# Access Compliance Report

### (Curb Ramps)

| Intersection ID: 42453                  | Main Street: KINGSLEY_VIEW_DR | Cross Street: ROYAL_CASTLE_CT           | Location: N            |
| ADA ID: 9082863C1A81                    | Ramp Type: PerpDiag           | Initial Pass/Fail: Fail                 | Overall Compliance: No |

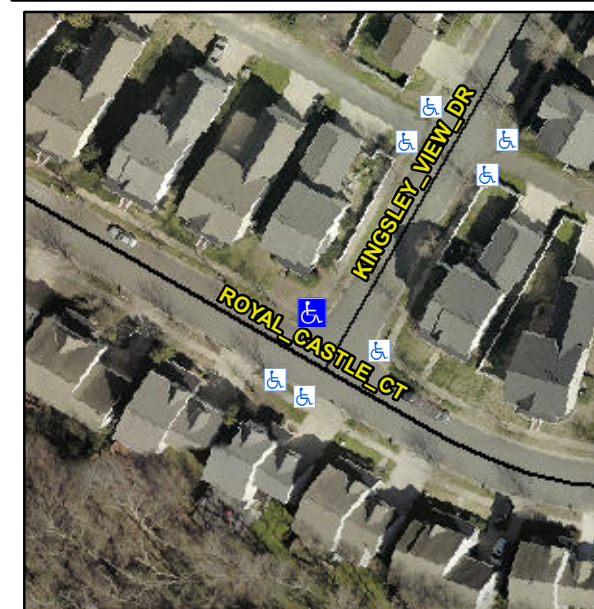
**Remove & Replace Curb Ramp With Two New Directional Ramps or Equivalent.**

**R304.5.1, R304.2.2, R304.5.3**

| Compliance | Description           | Data  | Compliance | Description                 | Data  |
|------------|-----------------------|-------|------------|-----------------------------|-------|
| N/A        | Ramp Length (in)      | 60.0  | No         | Ramp Slope (%)              | 11.1  |
| No         | Ramp Width (in)       | 46.0  | No         | Ramp XSlope (%)             | 6.3   |
